**RE: Glass Rite  
Conceptual Grading and Drainage Plan  
Engineer's Stamp Date: 10/28/22  
Hydrology File: B18D026**

Based upon the information provided in your submittal received 10/31/2022, the Conceptual Grading & Drainage Plan is approved for action by the DRB on Site Plan for Building Permit. However, the following comments need to be addressed prior to Building Permit approval of the above referenced project:

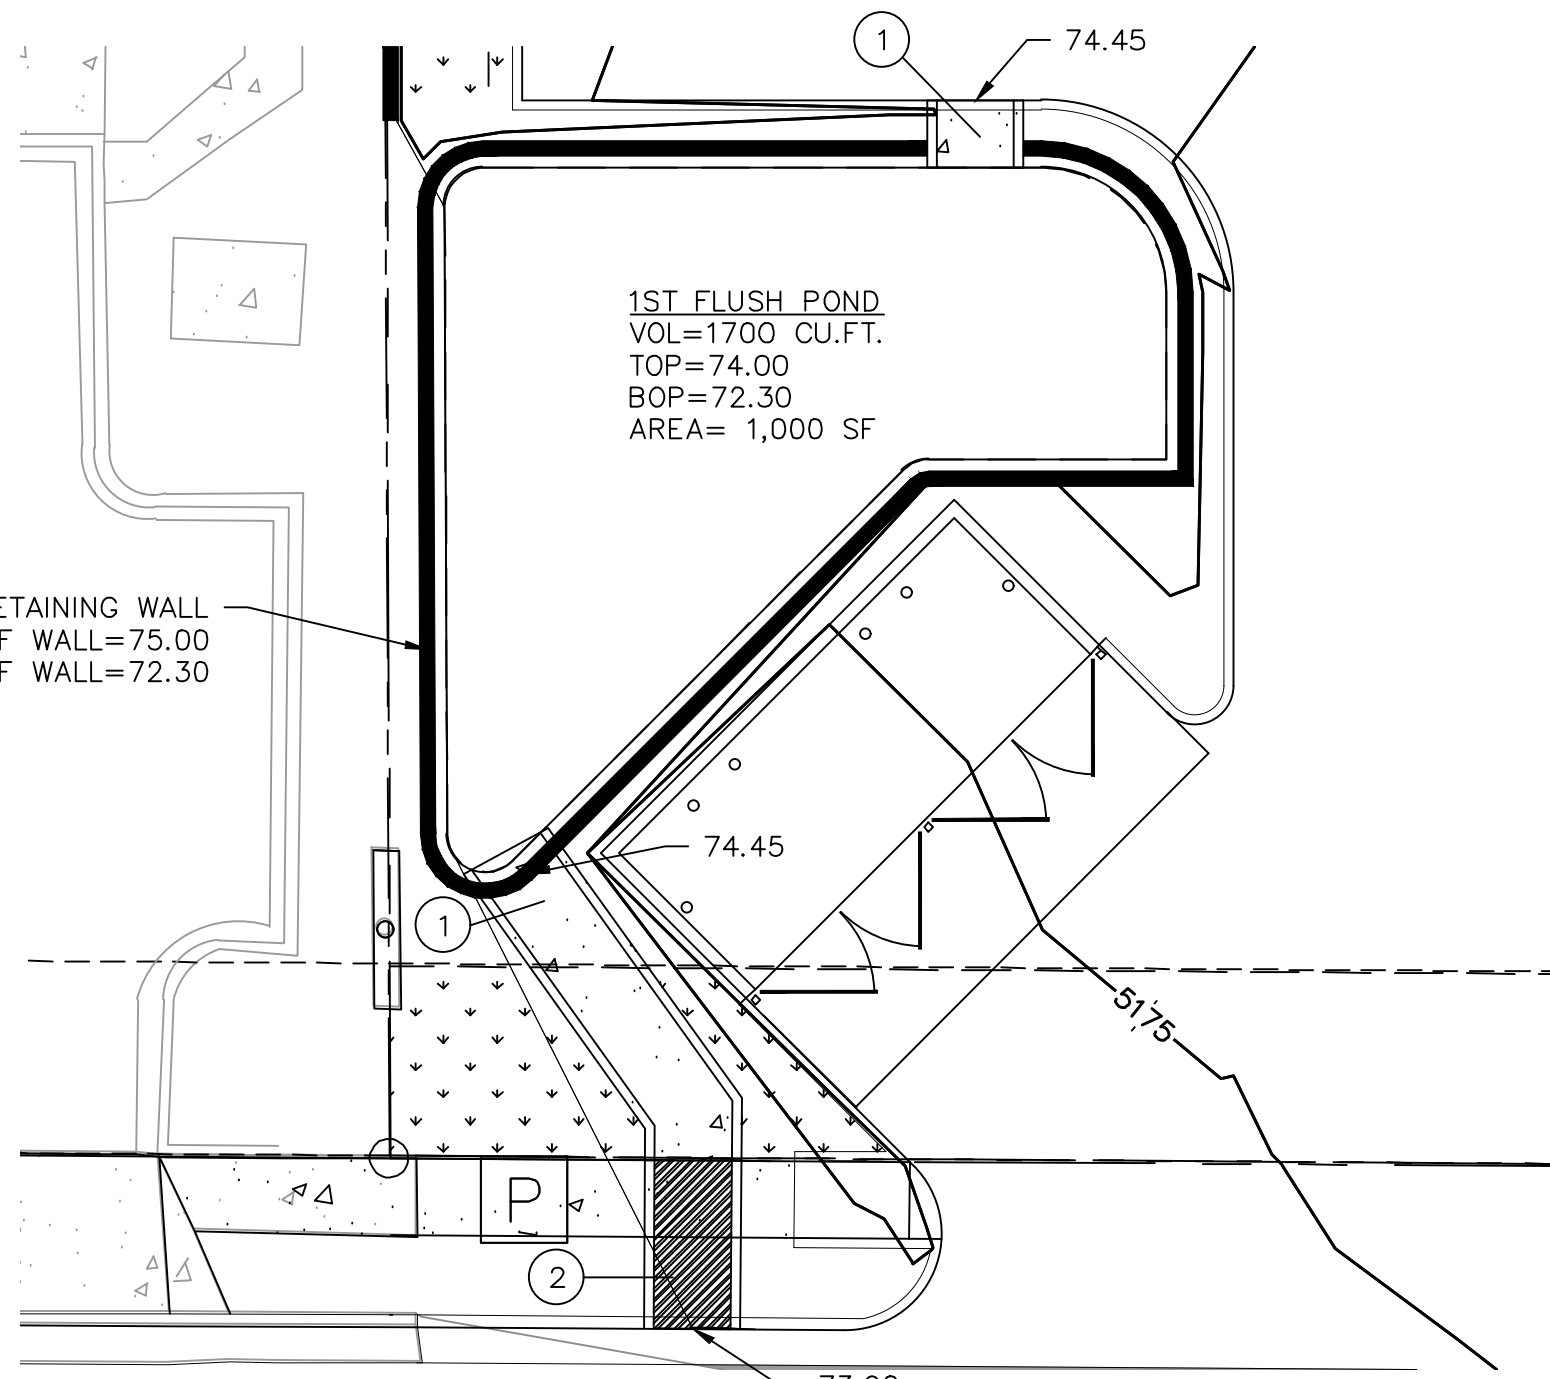
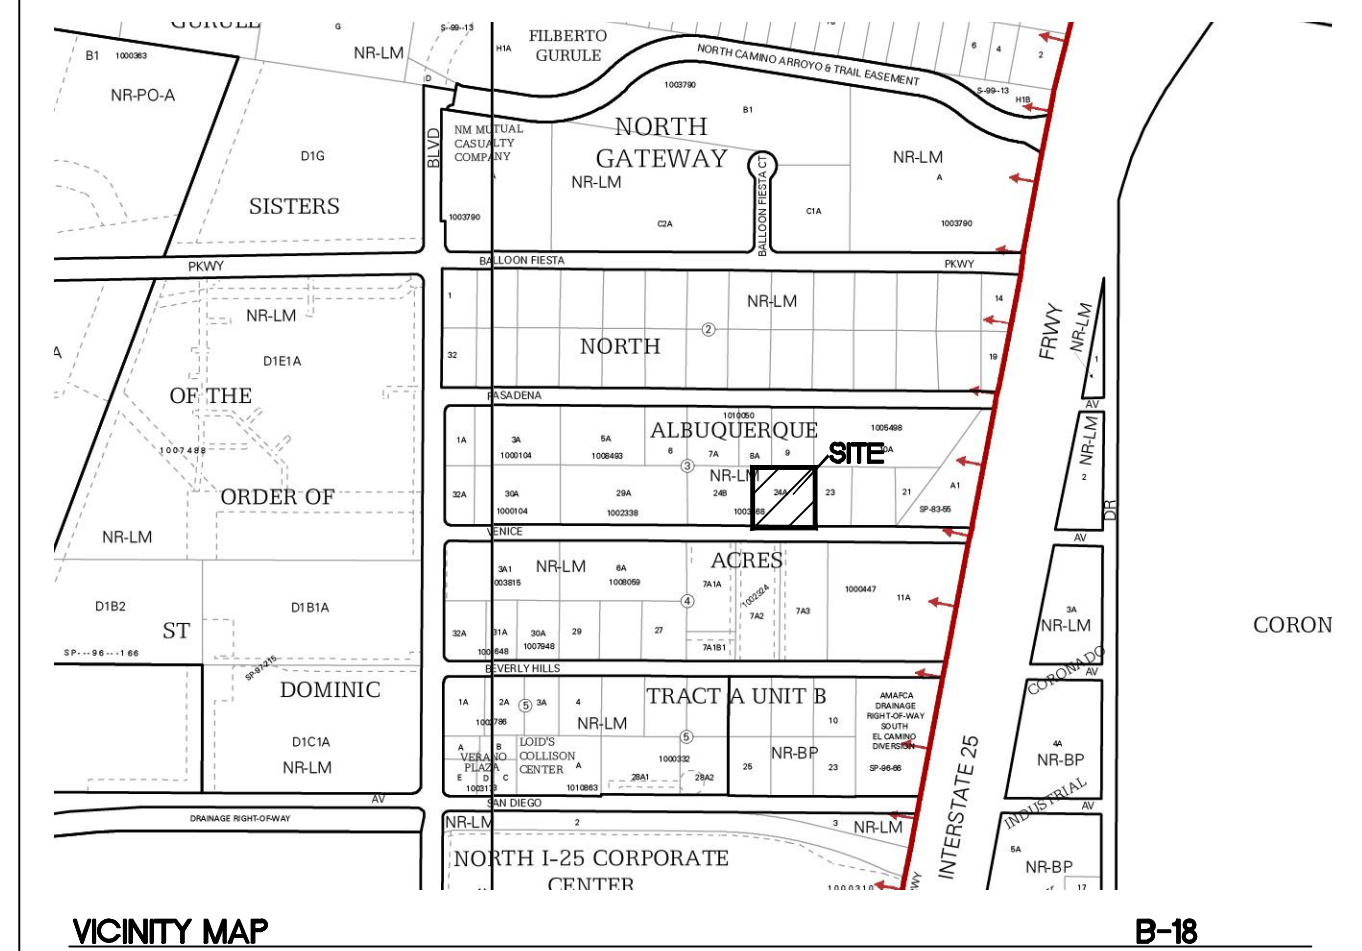
1. Please provide a cross section for the retaining walls along the property line showing the footer as an L shape.
2. Please provide the pipes and slump pump location in the truck dock area. Also please provide the cut sheet showing the performance curve of the pump.
3. Please provide a cross section of the SWQ pond.
4. Please provide some sort of diversion swale for the off-site drainage to the east. This can either drain to Venice or a retention pond (sized for the existing conditions of the small watershed) 100-10 day volume.
